Washington State
Department of Transportation

SUBJECT: 007999 – SR99 Bored Tunnel Alternative Design-Build Project
Federal-Aid No. BR-NH-STP-STPF-0099(111)
CO#073 – Harrison St. Util. Lid

**WASHINGTON STATE
DEPARTMENT OF TRANSPORTATION
CHANGE ORDER**

CONTRACT NO: 007999 FEDERAL AID NO: STP-BR-IM-0099 (J)
CONTRACT TITLE: SR 99, BORED TUNNEL ALTERNATIVE - DESIGN BUILD PRO
CHANGE ORDER NO: 73 HARRISON ST UTIL. LID

NORTH CONTRACT INTERFACE GENERAL SECTION A
IF003

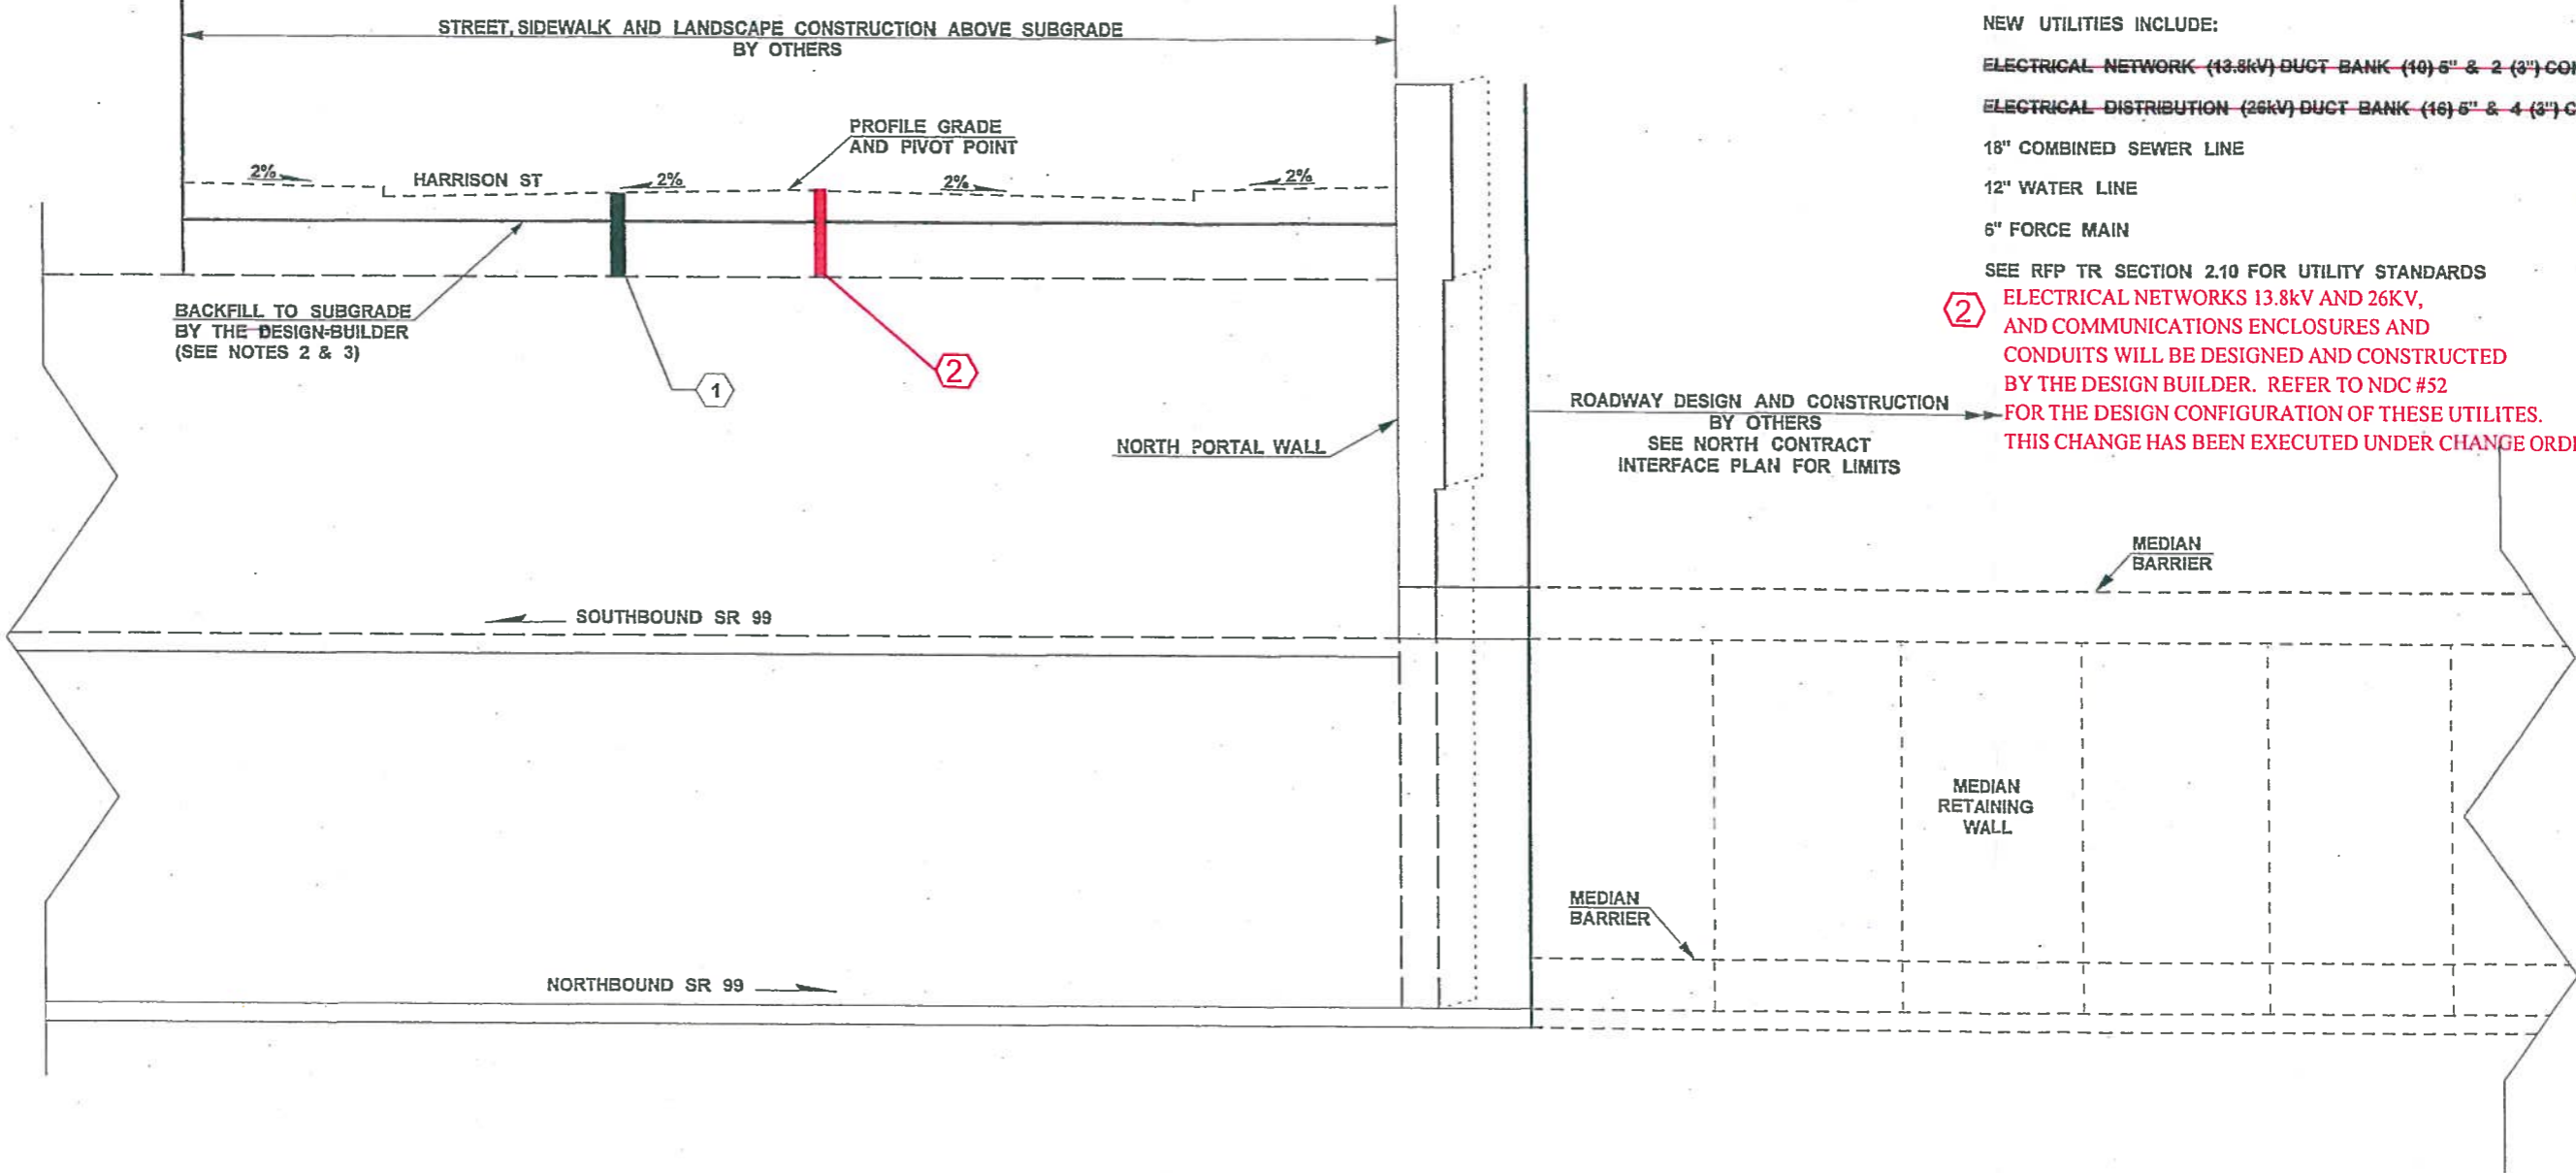
- ① CUT AND COVER STRUCTURE SHALL ACCOMMODATE NEW UTILITY INSTALLATIONS ON HARRISON STREET CONSTRUCTED BY OTHERS.
NEW UTILITIES INCLUDE:
ELECTRICAL NETWORK (13.8KV) DUCT BANK (10) 6" & 2 (3") CONDUITS CO #73
ELECTRICAL DISTRIBUTION (26KV) DUCT BANK (16) 6" & 4 (3") CONDUITS CO #73
18" COMBINED SEWER LINE
12" WATER LINE
6" FORCE MAIN
SEE RFP TR SECTION 2.10 FOR UTILITY STANDARDS
- ② ELECTRICAL NETWORKS 13.8KV AND 26KV, AND COMMUNICATIONS ENCLOSURES AND CONDUITS WILL BE DESIGNED AND CONSTRUCTED BY THE DESIGN BUILDER. REFER TO NDC #52 FOR THE DESIGN CONFIGURATION OF THESE UTILITIES. THIS CHANGE HAS BEEN EXECUTED UNDER CHANGE ORDER NO. 73.

Replace Appendix M9, sheet IF004-North Contract Interface General Section with the attached revised Appendix M9, sheet IF004-North Contract Interface General Section (Page 4 of 4 of this Change Order).
